Filtered Tailings in Indonesia

The Catastrophic Failure of a Disruptive Technology

Technical Report: Steven H. Emerman, PhD, Malach Consulting

Report prepared at the request of Earthworks, Submitted June 8, 2025, Revised June 29, 2025

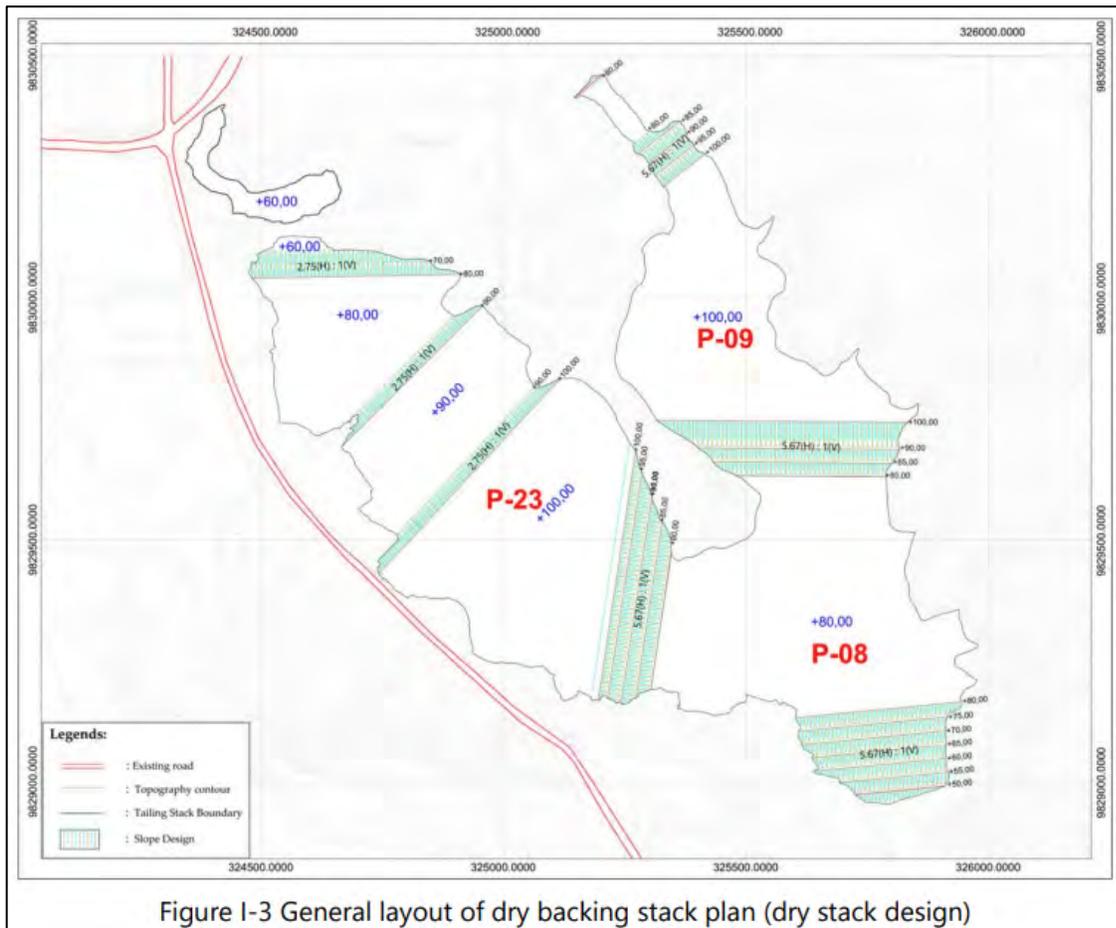
At the end of its useful life, the DSTF for PT HPL will have a height of 57 meters, footprint of 195 hectares, and maximum capacity of 57.2 million metric tons or 25.8 million cubic meters of tailings (PT Halmahera Persada Lygend (2024); see Table 4). Thus, the target dry density (density of solid particles, not including water) is 2.22 metric tons per cubic meter, which is within the mining industry range of 1.9 to 2.6 metric tons per cubic meter with 2.0 metric tons per cubic meter as a typical dry density (Cacciuttolo Vargas and Pérez Campomanes, 2022). The DSTF at the PT HPL mine is being constructed in three stages, starting with P-23, then moving to P-09, and concluding with P-08 (see Fig. 21). The construction includes both temporary and permanent rockfill buttresses, which consist of coarse fragments of ultramafic rocks with a minor amount of soil, all of which is obtained from the mine site (PT Lapi ITB, 2022; see Fig. 22). The tailings are being stacked far higher than the tops of the rockfill buttresses (see Fig. 22). Thus, the rockfill buttresses do not actually serve the function of dams, since if the tailings liquefied, they could easily flow over the tops of the buttresses (see Fig. 22). The actual density and corresponding maximum capacity by mass will be discussed in the section “Obi Island: Imminent Catastrophic Failure,” along with a possible reason for the short heights of the buttresses.

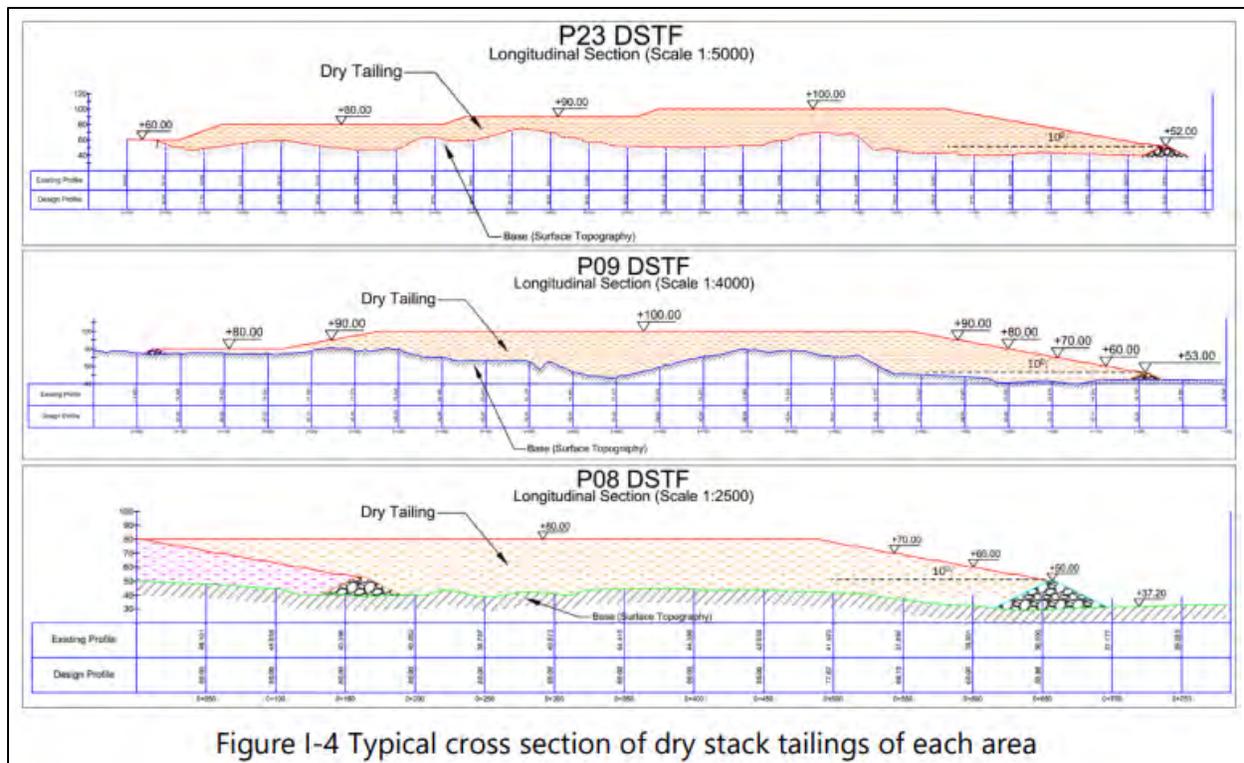
In terms of the design of the DSTF (see Figs. 21-22), the stability of the rockfill buttresses is most significant. PT Lapi ITB (2020) showed that the buttresses will be highly unstable (factor of safety = 0.948) in response to seismic loading at a buttress height of 20 meters (see Fig. 32c). According to PT Lapi ITB (2020), “From the simulation results, it can be seen with the buttress height of 20 meters, the FoS in the dynamic conditions [does] not meet the design acceptance criteria ... It is recommended that the maximum rise of the buttress during the construction stage is 15 meters.” The above finding could be the reason why the heights of the buttresses are restricted to 15 meters, despite the fact that the tailings are stacked far taller than the buttresses, so that the tailings could easily flow over the tops of the buttresses after liquefaction (see Fig. 22). It should be noted that the cross-section in PT Lapi ITB (2022) shows a rockfill buttress with a height of 18 meters at the downstream end of section P-08 of the DSTF (see Figs. 21-22).

SRK Consulting (2022a) did not comment on the wide range of circumstances under which the DSTF would be unstable in response to seismic loading (see Figs. 32a-d). However, SRK Consulting (2022a) implicitly noted the lack of any analysis of the post-liquefaction stability of the DSTF. With regard to the measured geotechnical parameters of the tailings, SRK Consulting (2022a) wrote, “The parameters seem to have reasonable values; however, a key gap is that the residual strength of the tailings is not considered.” The residual strength (also called the liquefied strength or the post-liquefaction strength) is the shear strength of the tailings after liquefaction (see Fig. 11). The contemporary practice is that tailings storage facilities should be designed so that they will not undergo catastrophic failure even after liquefaction. Thus, a minimum post-liquefaction factor of safety of 1.1 is a common standard (Barrick Gold, 2012; ICOLD, 2022; FEMA, 2025), which is calculated by assigning the residual strength to the potentially liquefiable tailings. Although it is not possible to calculate the post-liquefaction factor of safety of the DSTF, it is difficult to imagine how the DSTF could survive liquefaction, since the liquefied tailings could slide over the tops of the rockfill buttresses (see Fig. 22).

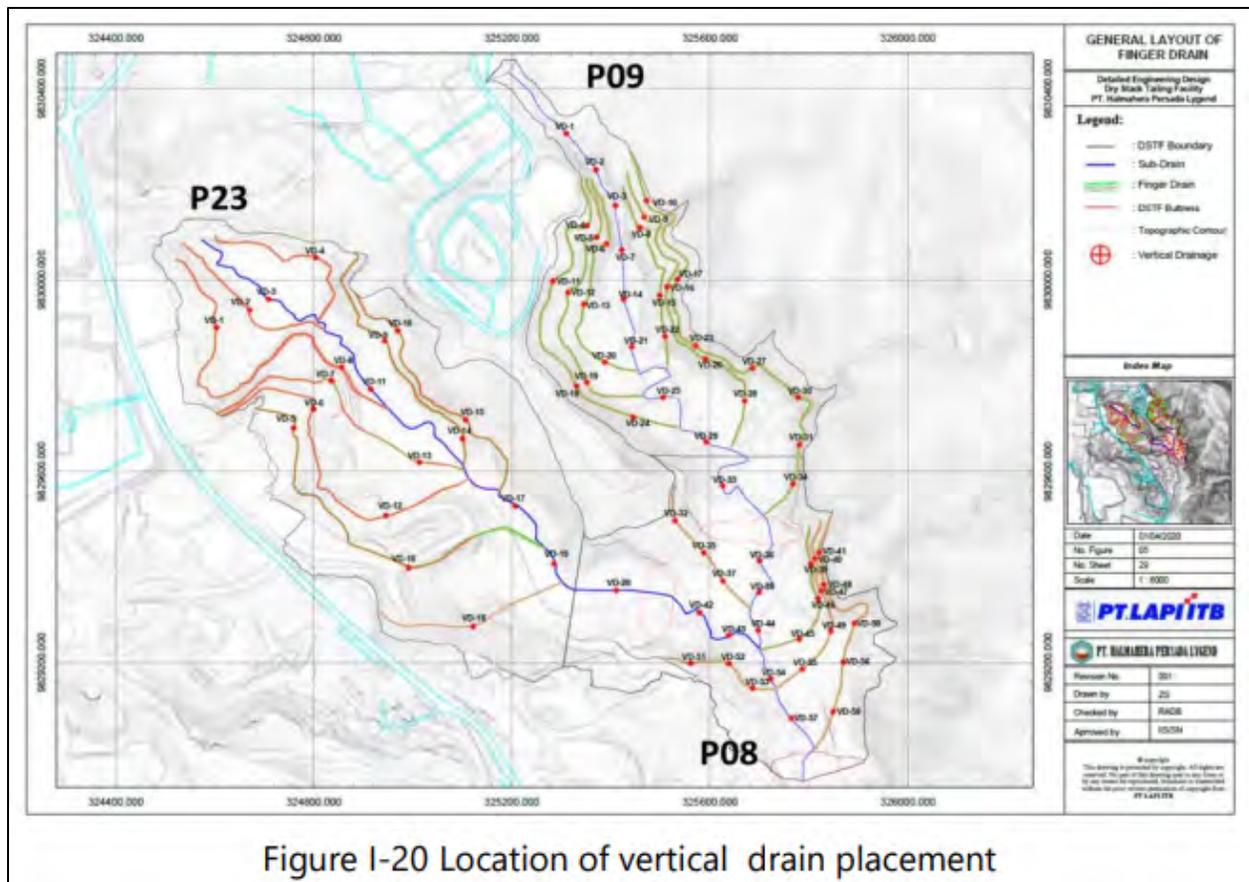
Figure 26. Although the Dry Stack Tailings Facility (DSTF) at the PT HPL mine had been operating for 1.5 years out of an anticipated lifetime of six years, SRK Consulting (2022a) noted that the drainage infrastructure had still not been completed. Moreover, SRK Consulting (2022a) could not understand how the drainage system was supposed to function. According to SRK Consulting (2022a), “[How] the discharge of P 23-SE and P09-SW drains away from the dry stack tailings facility is unclear. It was also noted that part of the drainage infrastructure was still under construction.” Figure from PT Lapi ITB (2022).

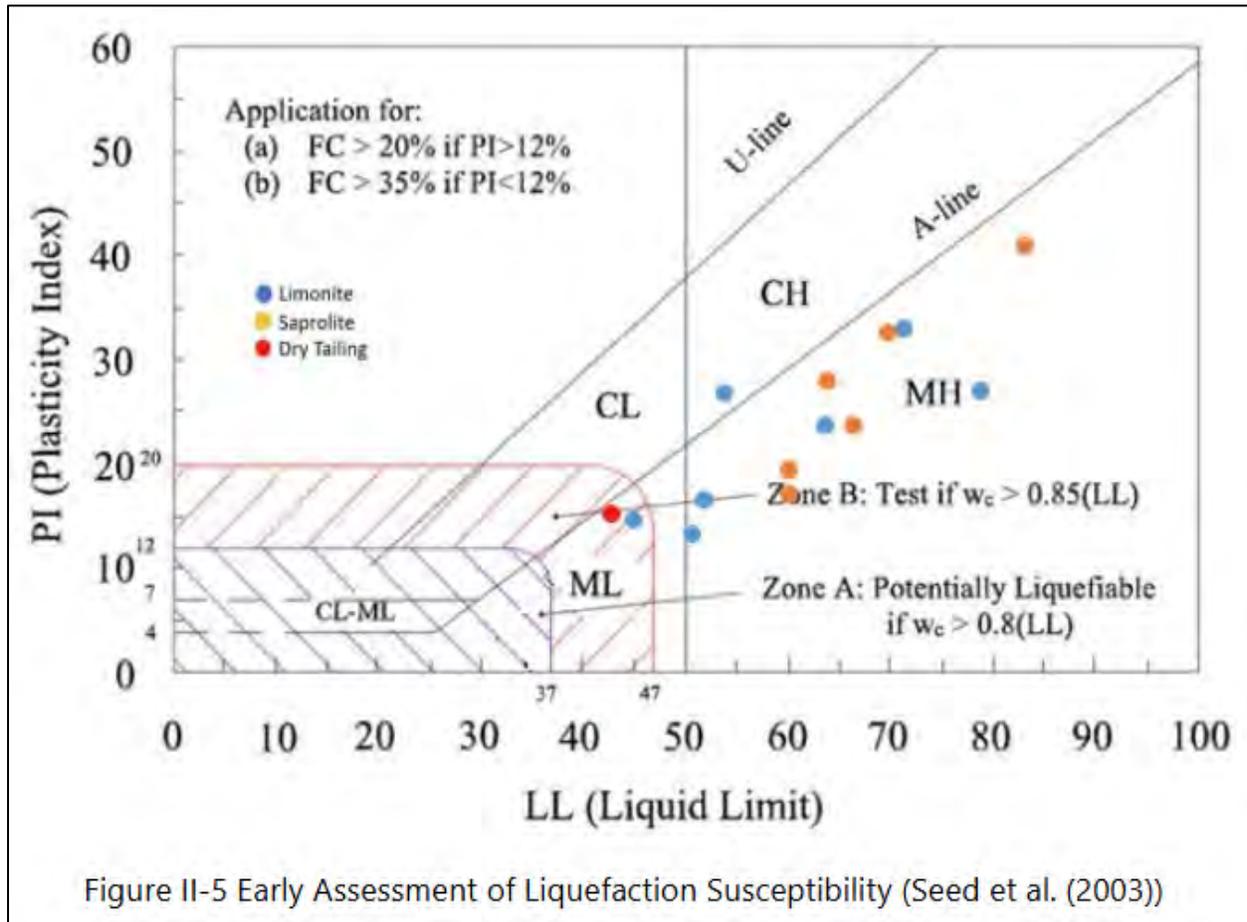
Hatch (2020), “It is observed that PT HPL’s Obi Project filtered tailings possess a moderate susceptibility to liquefaction and further testing was recommended.”

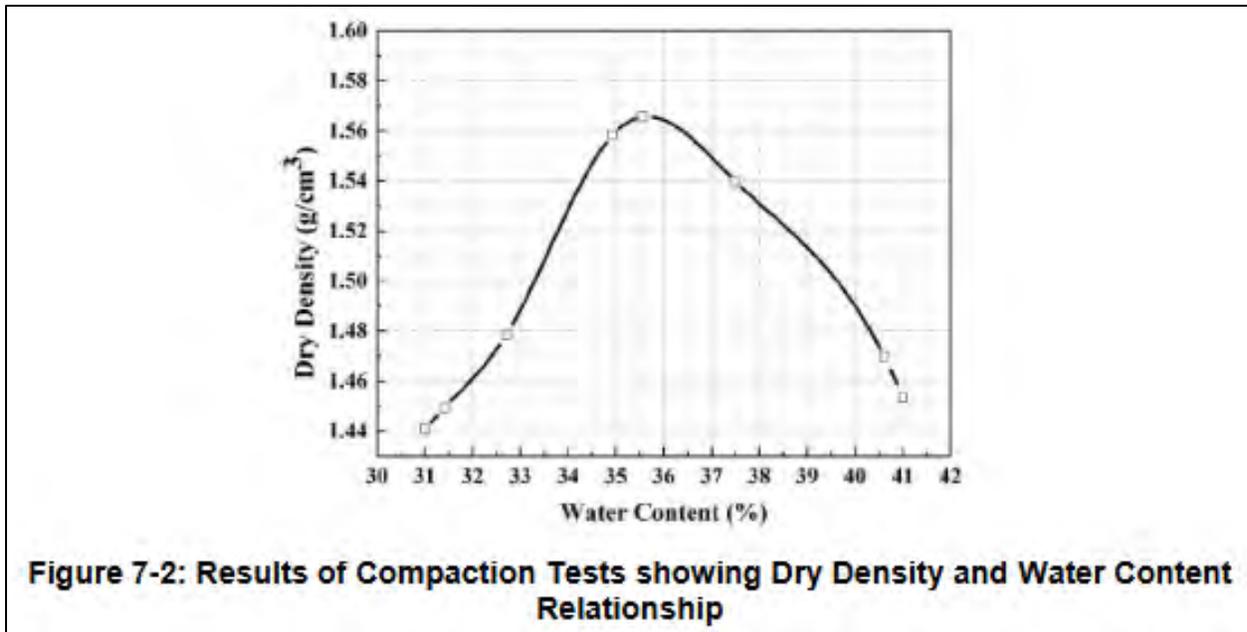
(2020) critiqued the maximum density determined by Hatch (2020) and suggested that a maximum density of 1.76 metric tons per cubic meter was more accurate. According to PT Lapi ITB (2020), “Resume of the laboratories result [laboratory results] and liquefaction potential assessment based on the CSL [Critical State Line] approach which [were] develops [developed] by Hatch, are: ... As an indication via phase relationships and based on particle size distribution (PSD), a theoretical dry density (ρ_d) of 1.76 t/m³ should be expected for a saturated soil that would yield a void ratio (e) of 1.22 considering a G_s of 3.9. Both SP [Standard Proctor] tests resulted in an maximum dry density (MDD) of 1.6 t/m³, which is not credible given that the result of the normally consolidated line (without any compaction) shows a void ratio of about 1.42 and a ρ_d of 1.61 t/m³ between the 50 and 400 kPa range. The compacted value and the normally consolidated values cannot be that similar for the same sample of soil.” The report by Hatch (2020) was submitted on September 18, 2020, while the report by PT Lapi ITB (2020) was submitted in August 2020, so that, apparently, PT Lapi ITB (2020) was responding to an earlier version of Hatch (2020).

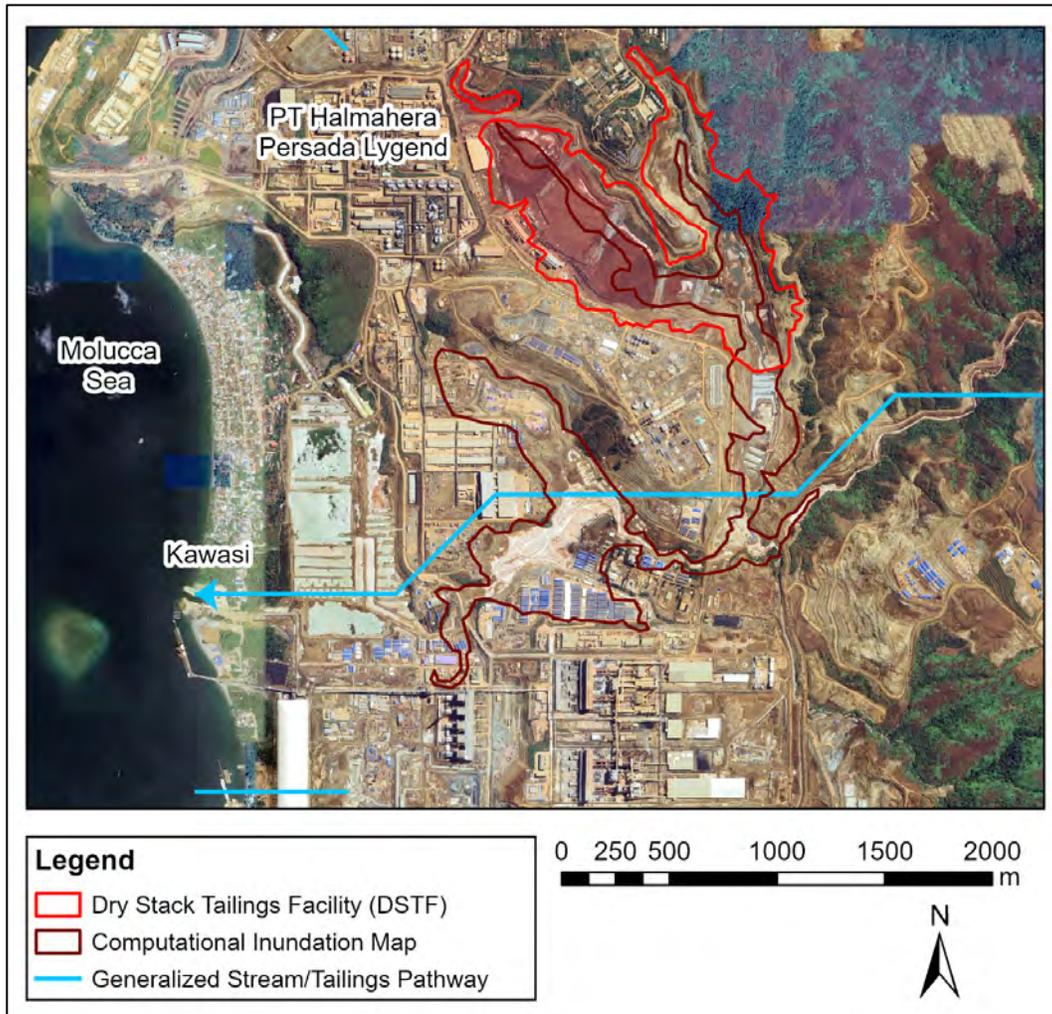
SRK Consulting (2022a) reprinted a map from PT Lapi ITB (2020) that showed the area that will be inundated with tailings following the catastrophic failure of the DSTF at the PT HPL project (see Fig. 34). PT Lapi ITB (2020) explained that the inundation area was developed using a deterministic model that assumed that the tailings had fully liquefied, but did not provide any of the other assumptions and input parameters behind the model. According to PT Lapi ITB (2020), “The assessment approach of DSTF risk failure is carried out through a DAM break analysis simulation. Even though the tailing material is a solid material and non-liquefaction material, the risk assessment is made very conservative by assumed [assuming] the tailings material is liquid. DAM break analysis is performed by numerical simulation based on predicted volume and flow, the model calculates the depth reached by the peak flow based on channel geometry, slope, and roughness coefficient.” The description of the tailings as “non-liquefaction material” is in contradiction to the extensive discussion of liquefaction potential and seismic instability that is available in the same document, as well as in Hatch (2020), and which has already been discussed in the subsection “Susceptibility to Liquefaction” (see Figs. 30a-b and 32a-d). PT Lapi ITB (2020) continued, “The result of [the] simulation show [shows] the maximum distance from the DSTF failure is around 2.2 Km to the downstream of [the] DSTF location.”

SRK Consulting showed a remarkable lack of due diligence in accepting the inundation map by PT Lapi ITB (2020) (see Fig. 34) at face value. First, although PT Lapi ITB (2020) did not provide any of the input parameters, the residual strength of the liquefied tailings is a crucial parameter and SRK Consulting (2022a) had already noted that the residual strength had never been measured. Second, the runout distance of only 2200 meters is completely out of line with the history of catastrophic failures of tailings storage facilities (see Table 3 and Fig. 19b). Based on the statistical model for catastrophic failures of tailings storage facilities that was discussed in the “Tutorial” section and a storage volume of 25.8 million cubic meters, in the most-likely scenario, the collapse of the DSTF will release 8.4 million cubic meters of tailings (33% of the storage volume) (see Fig. 19a). The statistical model should be regarded as highly reliable in the case of the PT HPL DSTF because the storage volume of 25.8 million cubic meters places the tailings facility well within the dataset that was used to develop the statistical model (see Fig. 19a). The height of 57 meters then predicts a runout distance of 47 kilometers under the most-likely scenario (release of 33% of the storage volume) and 161 kilometers under the worst-case

scenario (release of 100% of the storage volume) (see Fig. 19b). The statistical model should again be regarded as highly reliable because the storage volume of 25.8 million cubic meters and height of 57 meters places the tailings facility well within the dataset that was used to develop the statistical model for runout distance (see Fig. 19b). Thus, the conclusion that the released tailings will reach the Molucca Sea (see Fig. 34) is inescapable.
